DEVIATION REQUEST AND DECISION FORM

Project Name :	Crossroads North
Schedule No.(s) :	5408001008, 5408001029, 5408001050, 5408001051, 5408001052
Legal Description :	Lots 12, 13, 14, 15, 16 and 18, Hillcrest Acres, according to the plat thereon recorded May 12, 1960 at reception No. 153860, except that portion acquired by the department of Transportation, State of Colorado as described in rule and order recorded April 28, 2004 under reception no. 204068322, and except those portions conveyed to El Paso County by and through the Board of County Commissioners of El Paso County, Colorado by special warranty deed recorded December 17, 2014 at reception No. 214116021 and recorded December 17, 2014 at reception No. 214116022, County of El Paso, State of Colorado, Lot 17, Hillcrest Acres, County of El Paso, State of Colorado, except that portion conveyed to El Paso County by and through the Board of County Commissioners of El Paso County, Colorado by special warranty deed recorded December 30, 2014 at reception No. 214119767. Lot 19, Hillcrest Acres, County of El Paso, State of Colorado, as amended by surveyor's statement recorded June 22, 1960 in book 1812 at page 136, except that portio

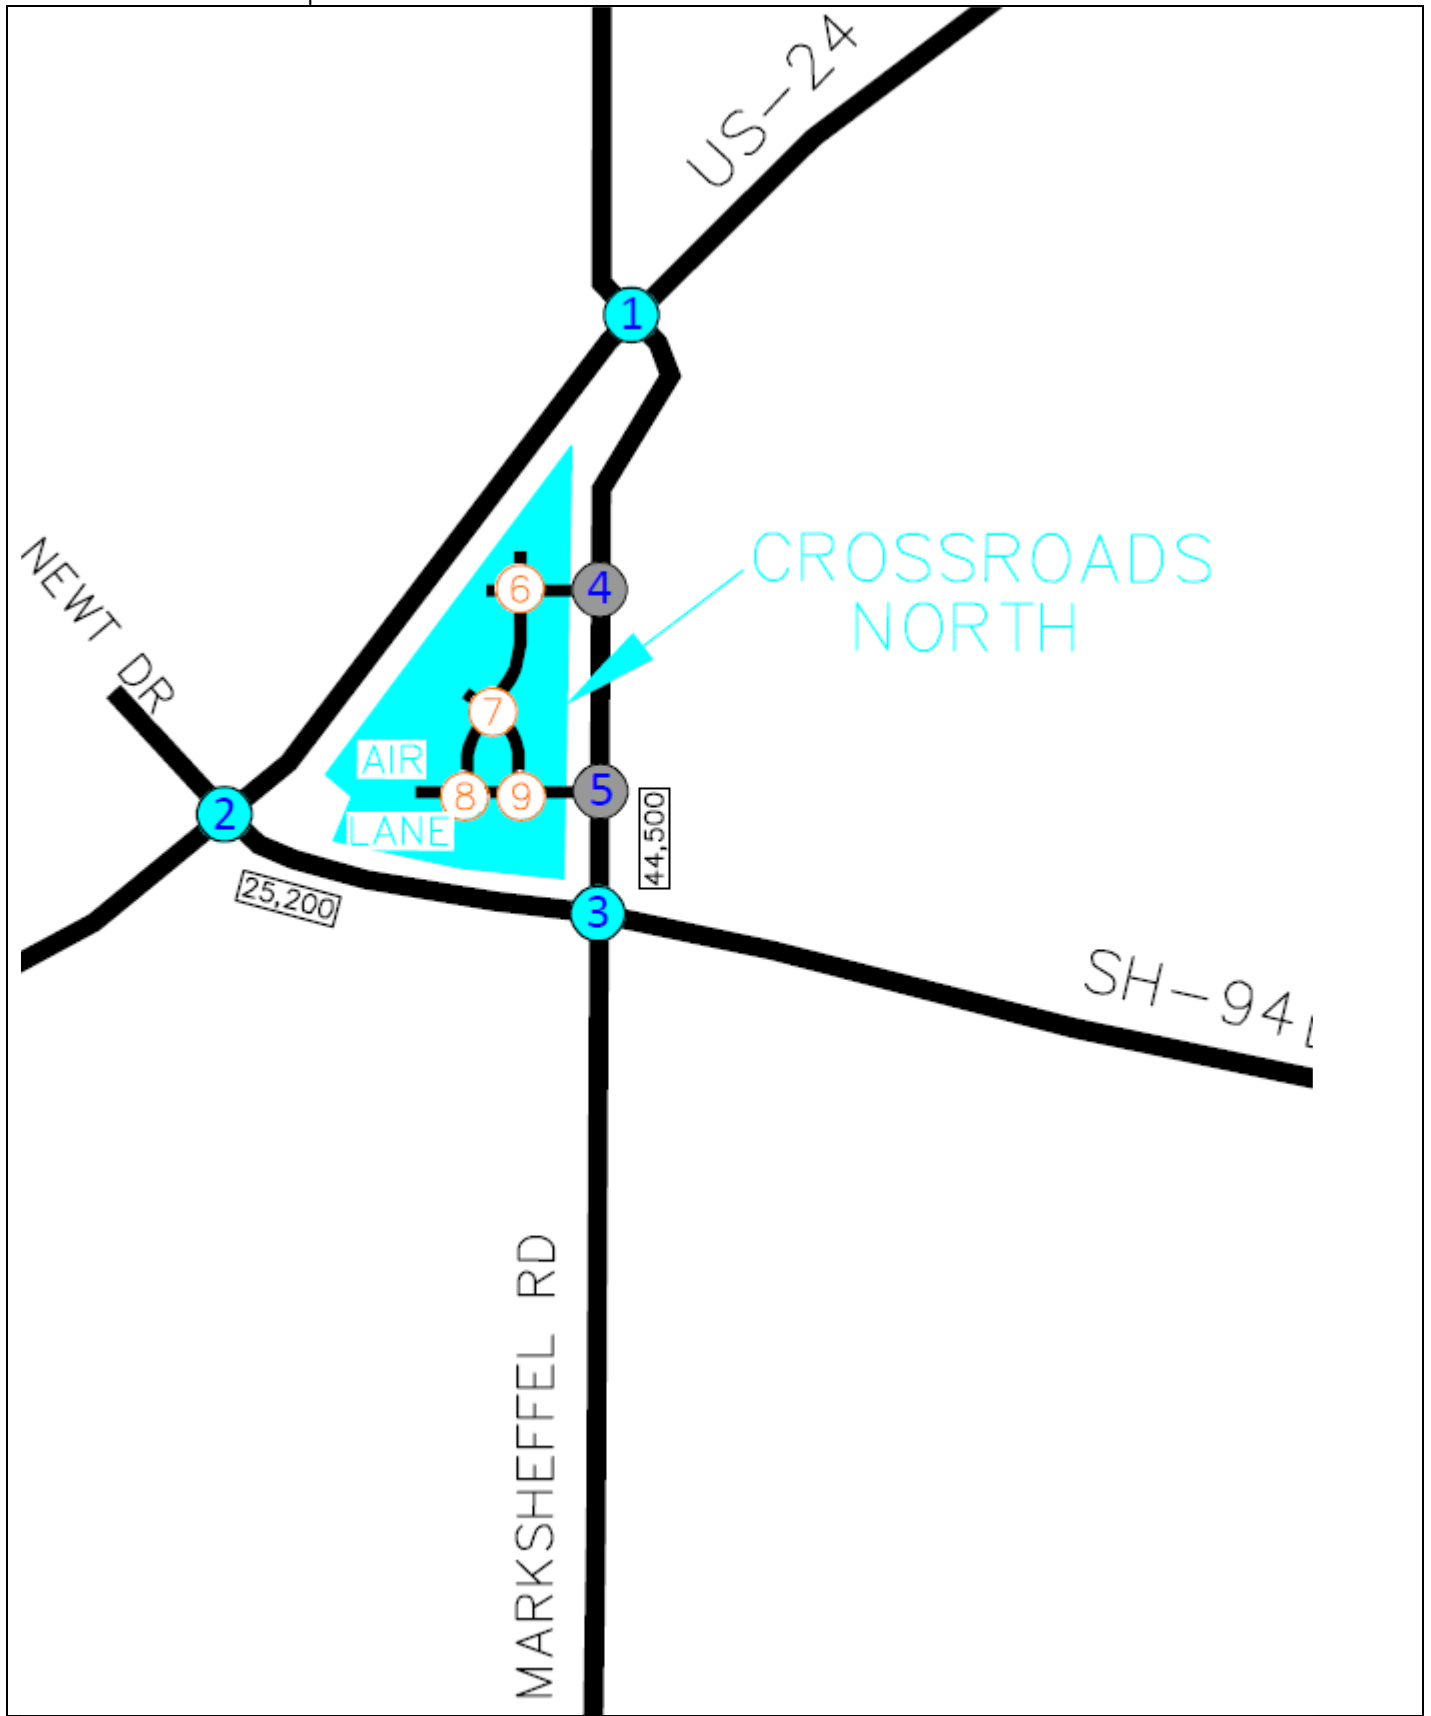
Not reviewed at this time. See comments on the TIS and the deviation request for full movement at access number 4.

The deviation for 3/4 movement is likely to be denied so this deviation request would no longer be applicable.
